12' X 20' ORGANIZER  
5/12 PITCH

12' X 20' ORGANIZER  
5/12 PITCH

Re: Structural Certification  
10', 12', & 16' Organizer Sheds

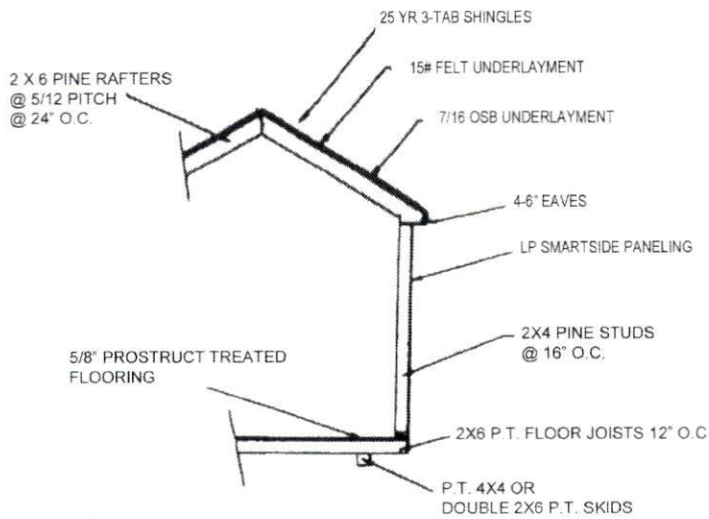
\*SEE ENGINEER LETTER.  
BUILDING ANCHORED AT 4 CORNERS.

The floor framing consists of 2x6 joists at 16" on center supported on three (3) 4x4 "skids". Please be advised that the 2x6 floor joists can have a maximum of 10 1/2" cantilever beyond the 4x4 supports. Furthermore, please be advised that the 4x4 skids must be intermediately supported by piers at a maximum of 4' on center. Alternatively, if a double 2x6 beam is used for the skids, they must be supported at a maximum of 5' on center. The skids may bear on 8"x16" CMU piers which bear directly on the soil. The piers may be constructed with dry stacked concrete masonry units, with solid units top and bottom and hollow 8" concrete

masonry units for the remainder of the pier at a maximum height of 36". The floor framing should be tied down with 30" screw anchors and 1" metal strapping across the floor joists.

ROOF FRAMING

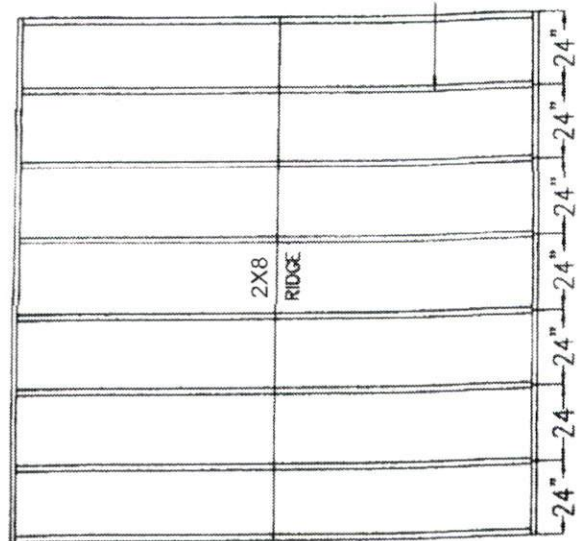
This variation consists of a 12' wide shed with a gable roof system. The roof consists of 2x6 rafters @ 2'-0" on center at a 5:12 or 9:12 pitch, and the walls are constructed with 2x4 studs at 16" on center. Please be advised that the rafters shall be cross-tied with 2x4 collar ties located at the 1/3 point extending downward from the ridge and spaced at 4'-0" on center. A 2x ridge board shall be provided for the connections of the opposing rafters at the ridge. The collar ties should be attached at each rafter with a minimum of (8) 10d nails
